REQUEST FOR ADDITIONAL INFORMATION

MARK I CONTAINMENT LONG TERM PROGRAM

PLANT UNIQUE ANALYSIS REPORT

BRUNSWICK STEAM ELECTRIC PLANT

Figure 3.6.1.1-12 Downcomer/Vent Header Finite Element Projection on $X_1 - X_2$ Plane

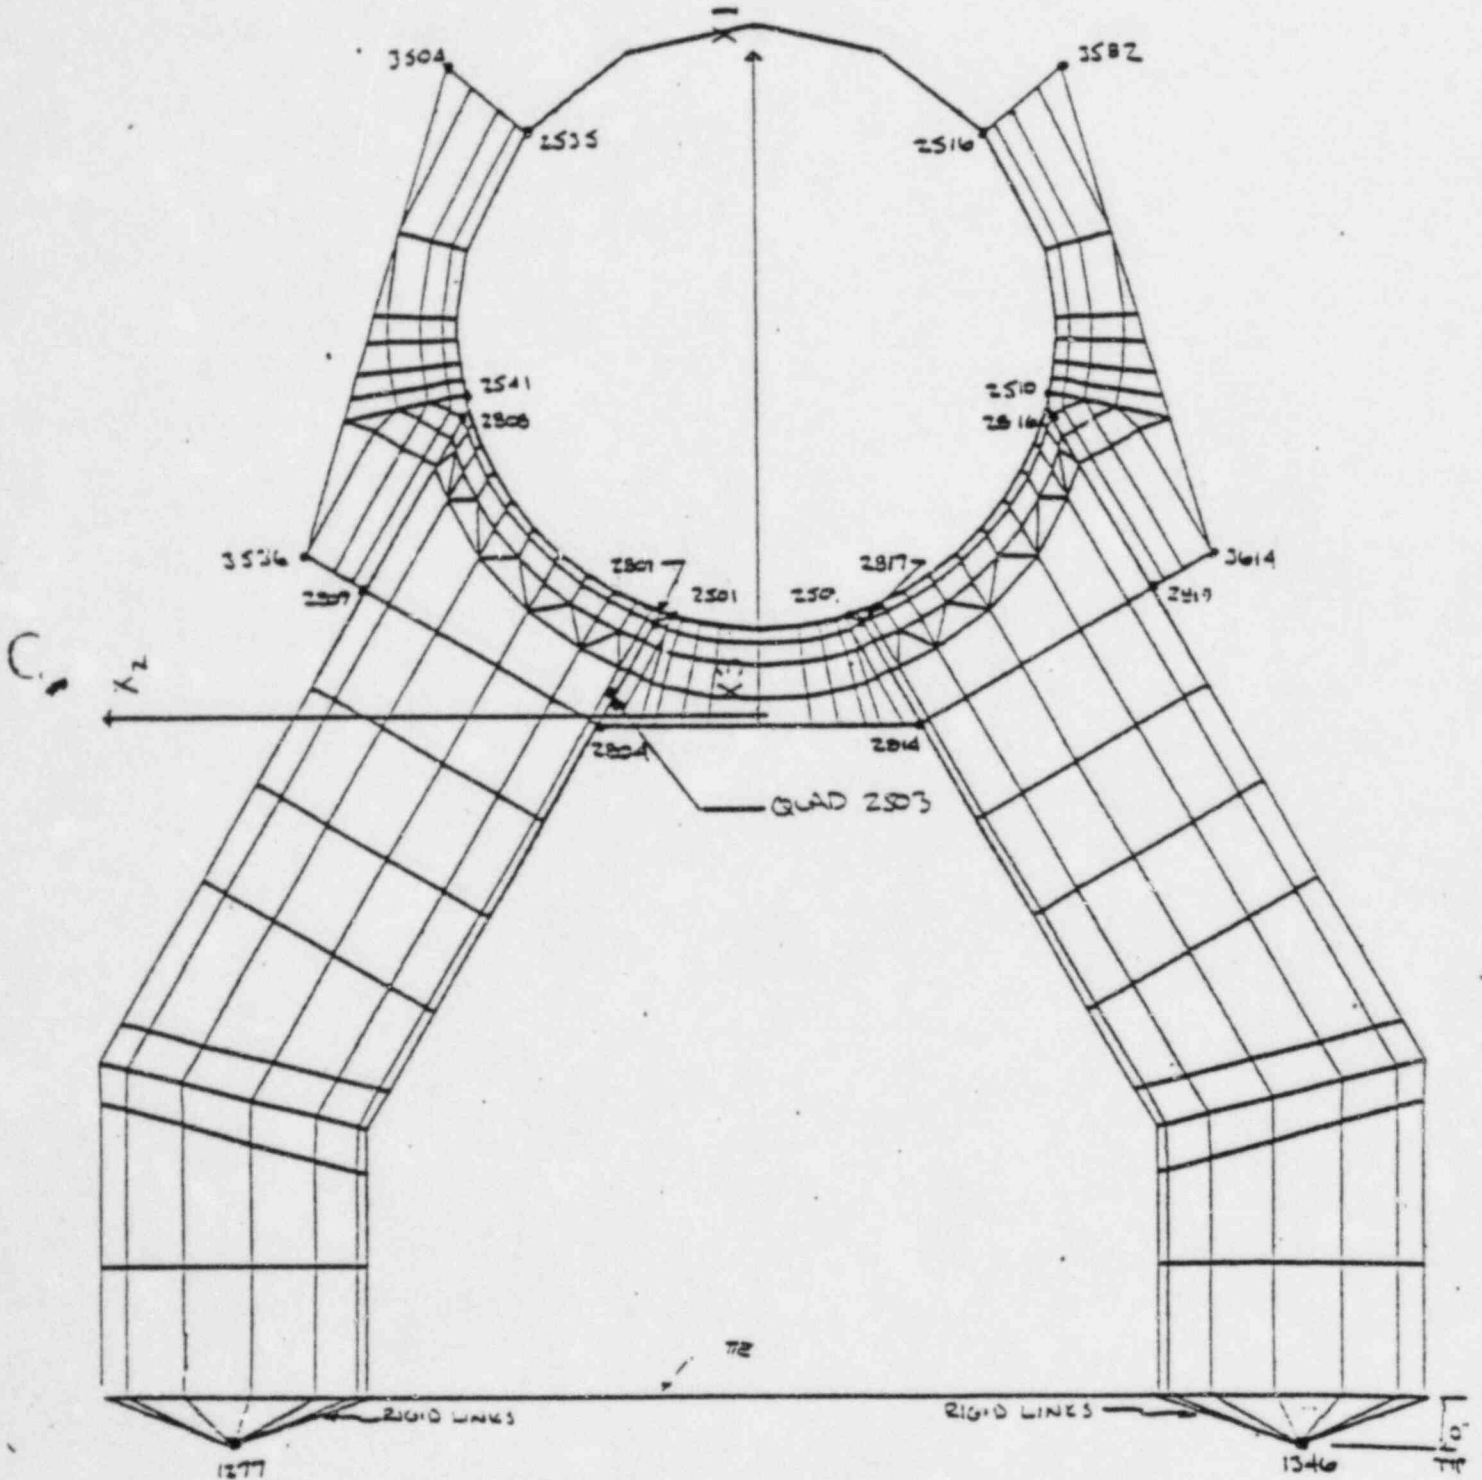
RAI 25b Also indicate on Figure 3.6.1.1-12 and -13 (4), the locations corresponding to the high stress intensity values given in Table 3.8.4.3.1 (4).

The calculated maximum stress intensity values at element locations in the regions of discontinuity are shown on Figure Item 25-A, Attachment RAI 25b-1. Locations corresponding to high stress intensity values given in Table 3.8.4.3.1 are marked on Figure 3.6.1.1-12, Attachment RAI 25b-2 and Figure 3.6.1.1-13, Attachment RAI 25-2, (attached).
